Development Approval No: DEV2024/1571

Property Location: Nirimba Drive, Nirimba (Lot 8 on SP334576)

Application Description: Material Change of Use for Child Care Centre

Subject: Minor Change Application - Traffic Statement

Figure 1: Extract from Approved Plan (Site Plan – Ground Floor)

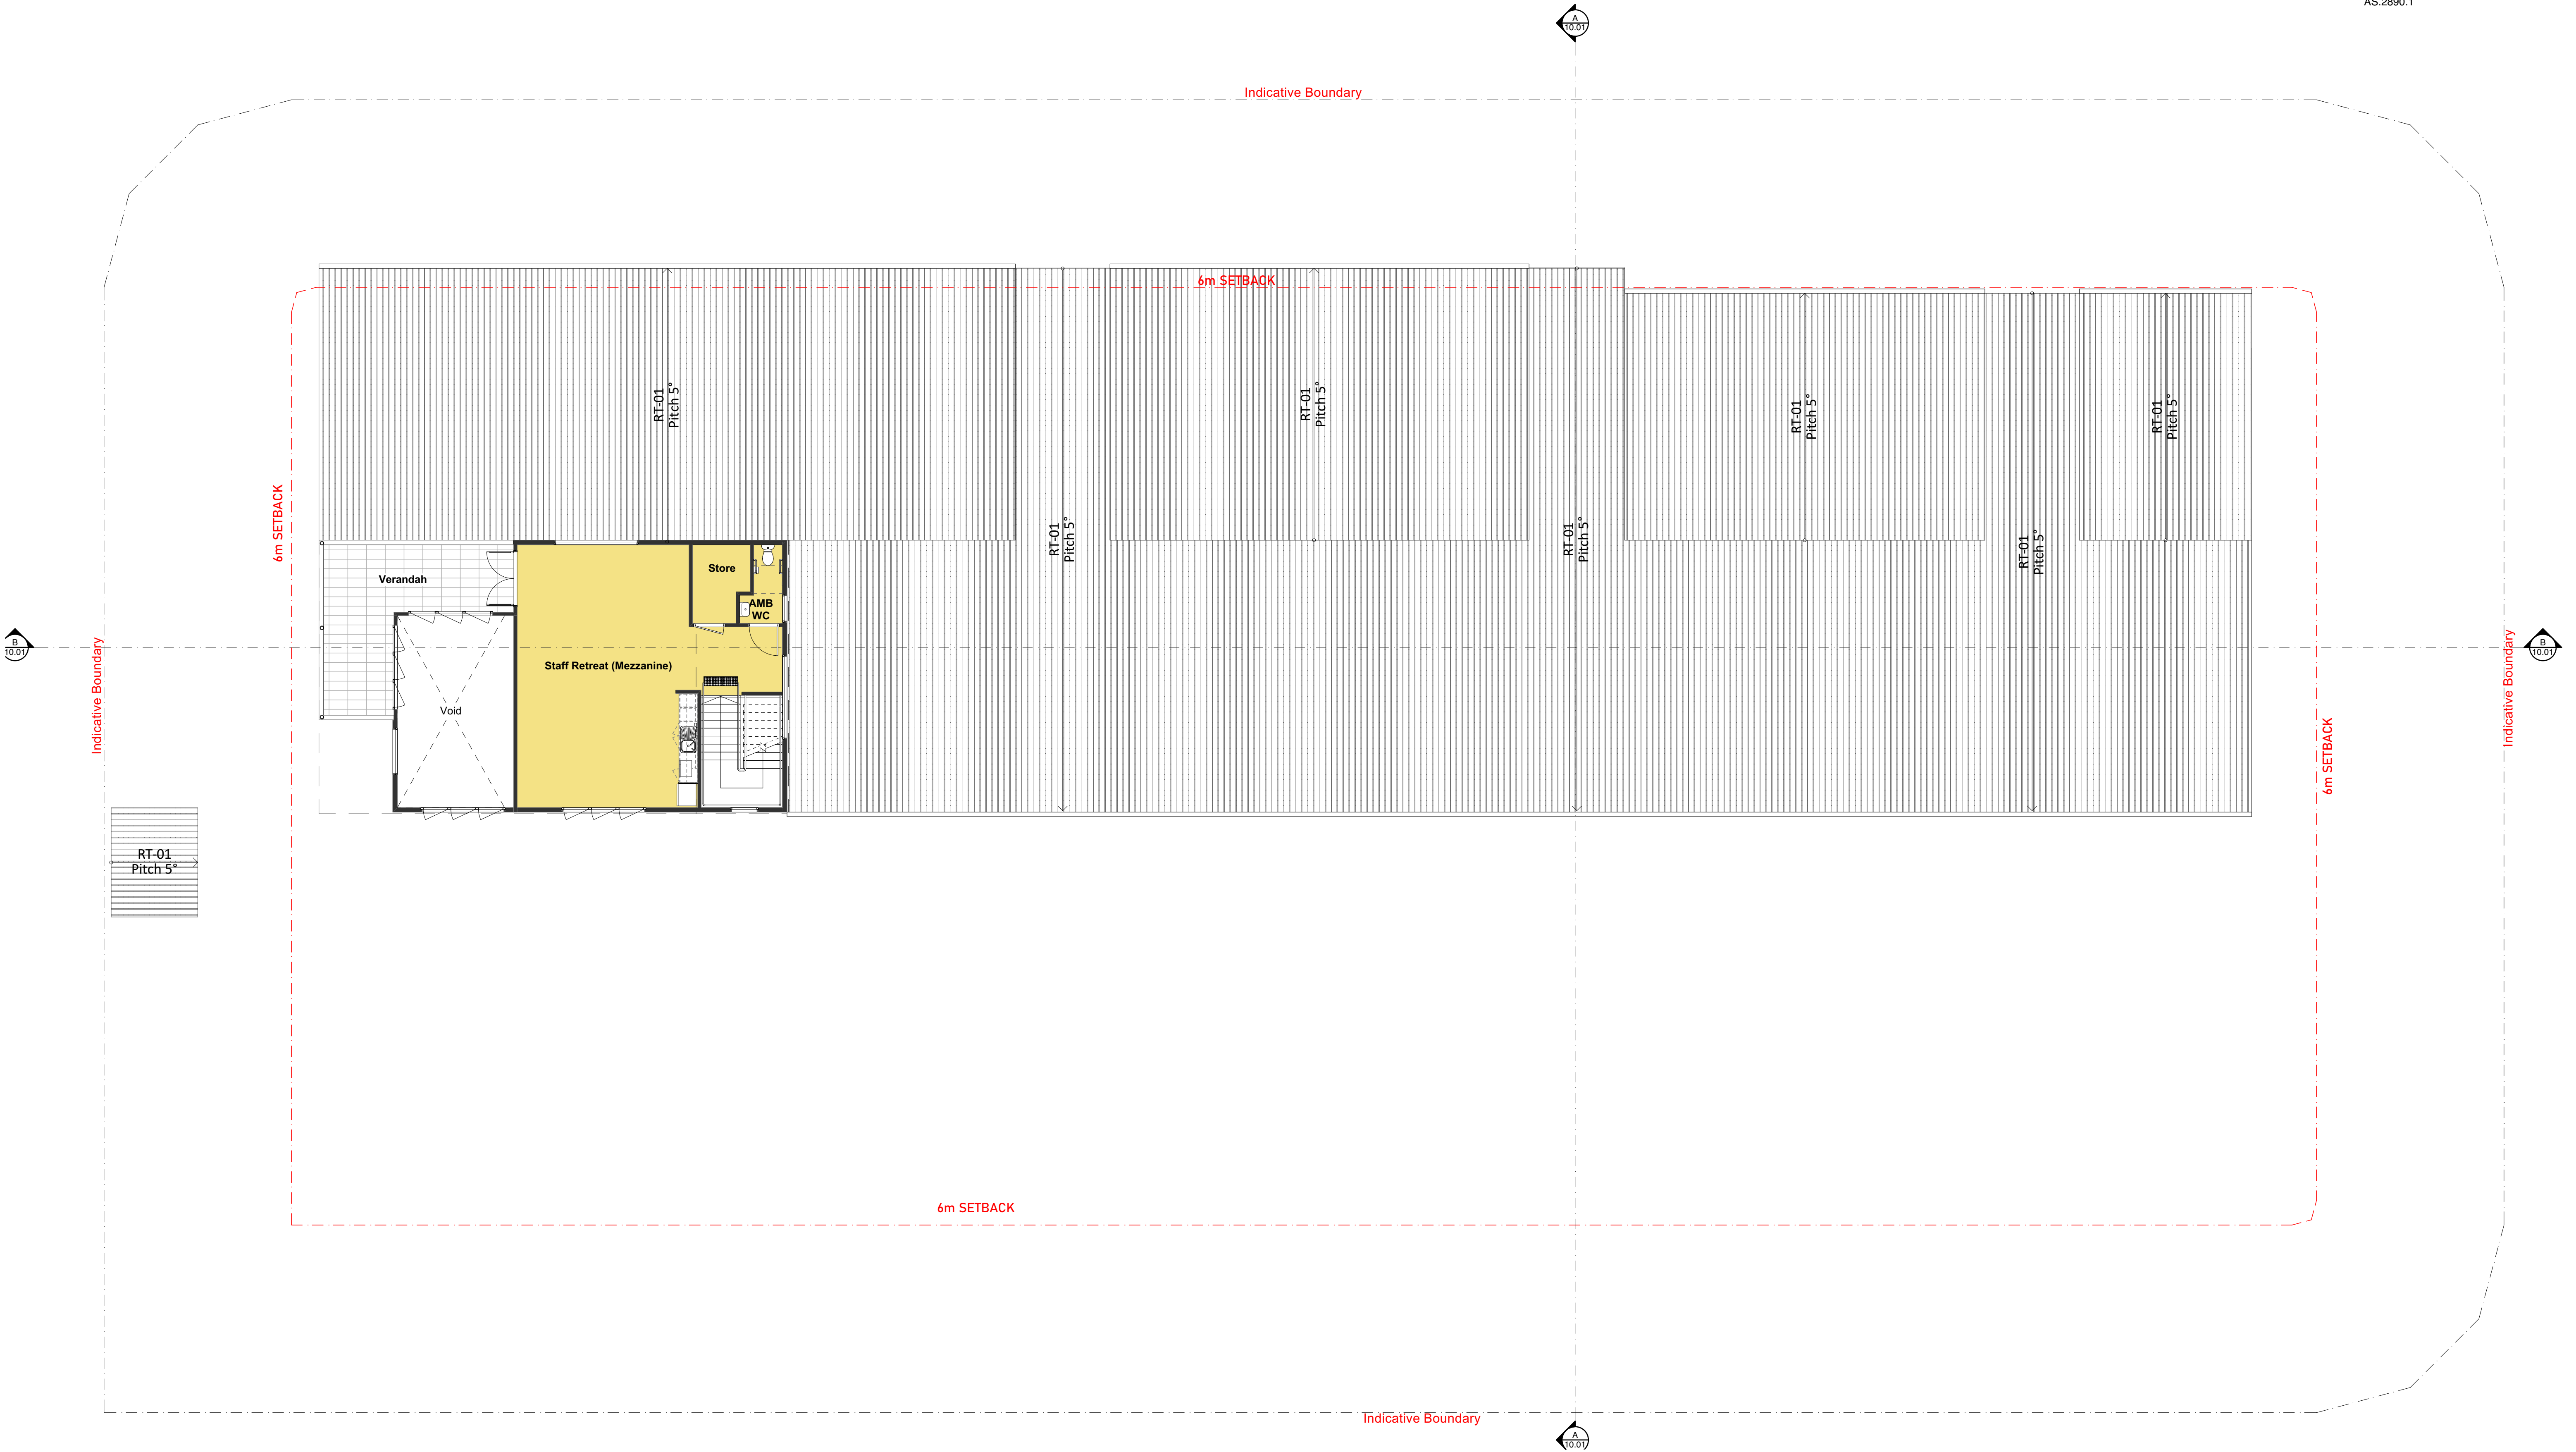
The relevant plans showing the approved development are included for reference as **Attachment 1**, with an extract from the site plan provided as **Figure 1** below.

As shown in these plans, the approved development is a child care centre accommodating 130 children, with at-grade parking for 38 cars including 25 staff bays and 13 bays for drop-off and pick-up of children (including one (1) parking space for people with disabilities).

Vehicular access under the approved scheme was provided by way of an all-movements driveway located approximately midway along the southern site frontage, providing separation from both the intersection to the east, and the road bend to the west. The approved driveway was 6.2m wide, which is adequate to accommodate two-way passenger vehicle flow and access/egress by the largest vehicle expected to require access to the site, which is a refuse collection vehicle of approximately 10.2m length.

Figure 2: Extract from Proposed (Amended) Plan (Site Plan – Ground Floor)

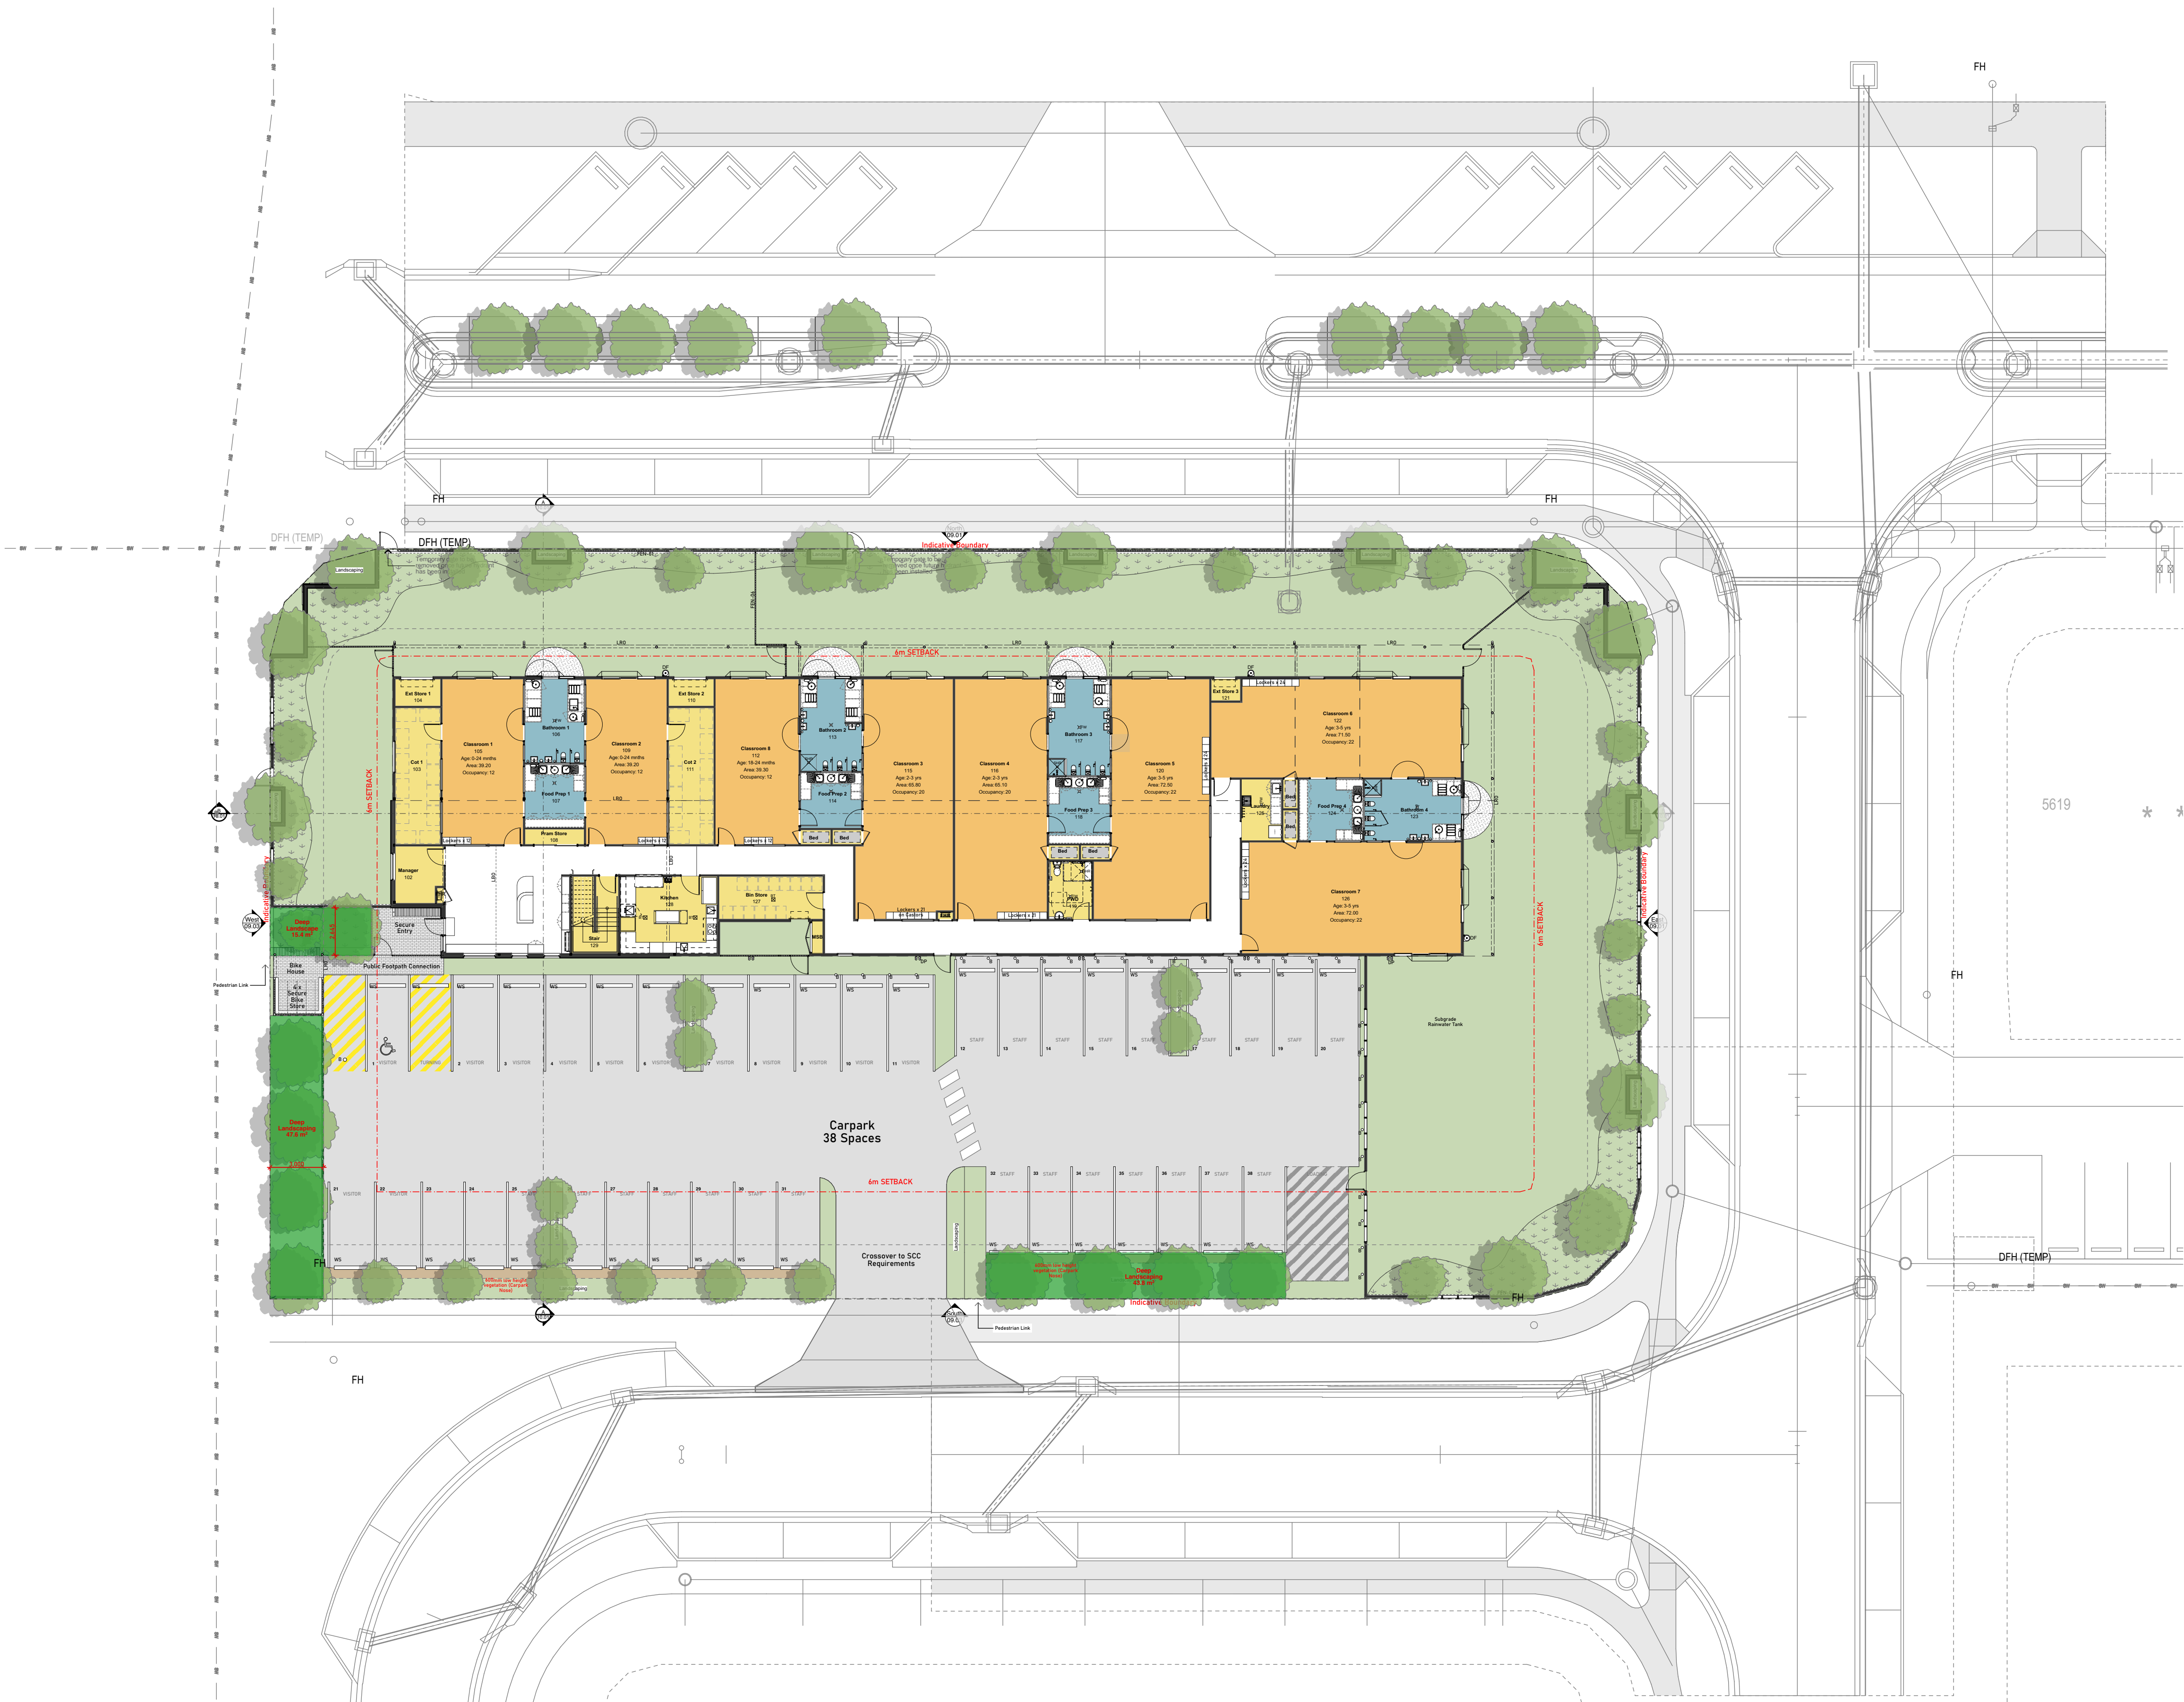
The scheme which is the subject of this change application is shown in the plans included as **Attachment 2**, and the extract from the site plan provided as **Figure 2** over page.

The key change to the approved scheme is the conversion of a yoga room to an activity room, with the capacity of the child care centre increased from 130 children to 142 children in order to meet the specific requirements of the future operator. The forecast number of staff has also increased slightly from 20 to 23 staff, in response to the increased in the capacity of the centre.

As shown in the plans included as Attachment 2, a total of 38 on-site car parking spaces are proposed under the amended development scheme, achieving the above car parking rate which was determined to be appropriate during a recent Planning and Environment Court matter.

Of the 30 car parking spaces proposed, 23 spaces are to be staff bays, leaving 15 car parking spaces available for drop-off and pick-up of children.
